APPLICATION NO.	FILING DATE	FIRST NAMED INVENTOR	ATTORNEY DOCKET NO.	CONFIRMATION NO.
09/750,504	12/26/2000	Junji Yoshida	6635-60104	6968

Office Action Summary

- 1) ☒ Responsive to communication(s) filed on 21 November 2002.
- 2a) ☒ This action is **FINAL**. 2b) ☐ This action is non-final.
- 3) ☐ Since this application is in condition for allowance except for formal matters, prosecution as to the merits is closed in accordance with the practice under *Ex parte Quayle*, 1935 C.D. 11, 453 O.G. 213.

F I G. 1

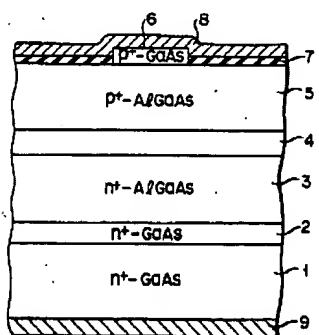
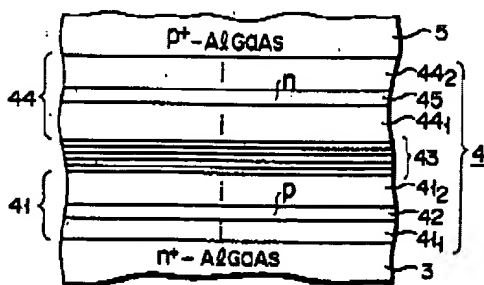
9. Claims 1-3, 5-15, 17-19, 29, 34, 36-38, 40-43 are rejected under 35

U.S.C. 102(b) as being anticipated by McIlroy et al (4,701,774). McIlroy et al discloses the claimed invention. Figures 1 and 2 illustrate a semiconductor laser device comprising a doped semiconductor cladding layer (3), a semiconductor optical layer (41₂); and an undoped semiconductor spacer layer (41₁) positioned between the cladding layer (3) and the optical confinement layer (41₂). Note further the substrate (1), the semiconductor active layer (43) for generating light, a semiconductor upper optical confinement layer (44₁); a p-doped semiconductor upper cladding layer (5); and electrodes (8,9) for current injection to the device. See col. 6 lines 60-63 for the suggestion of InP and InGaAsP.

FIG. 1

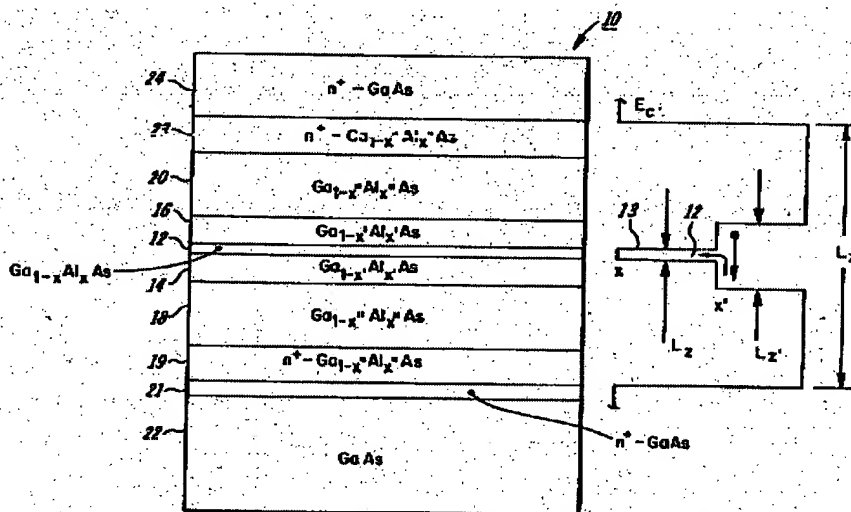
10. Claims 1-4, 6, 11, 29 are rejected under 35 U.S.C. 102(b) as being anticipated by Burnham et al (4,585,491). Burnham et al discloses the claimed invention.

Figure 1 illustrates a semiconductor laser device (10) comprising a doped semiconductor cladding layer (19), a semiconductor optical confinement layer (14); and an undoped semiconductor spacer layer (18) positioned between the cladding layer (19) and the optical confinement layer (14). Note further the substrate (22), the semiconductor active layer (12) for generating light.
